## RHF Bulk Power Supply Assessment

To be within the green energy ring it was planned that this supply would come from Northwest Sub – Essential loads

Figure 3 c: Intended spare unequipped functional unit.

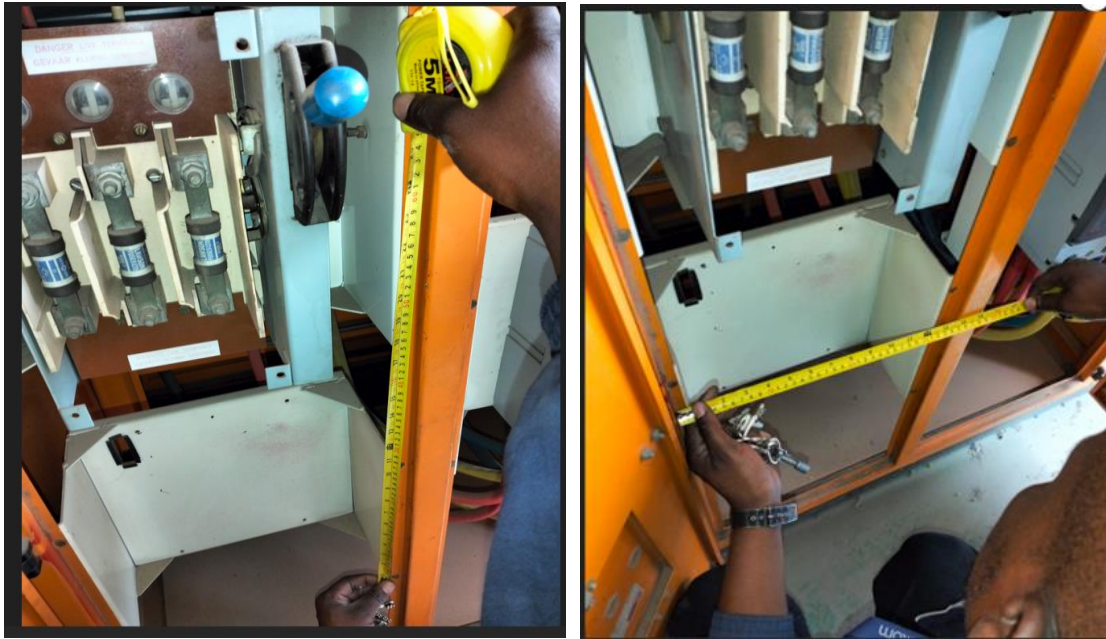
3. Exploded view of the intended bulk supply (Figures 4a , 4b and 4c)
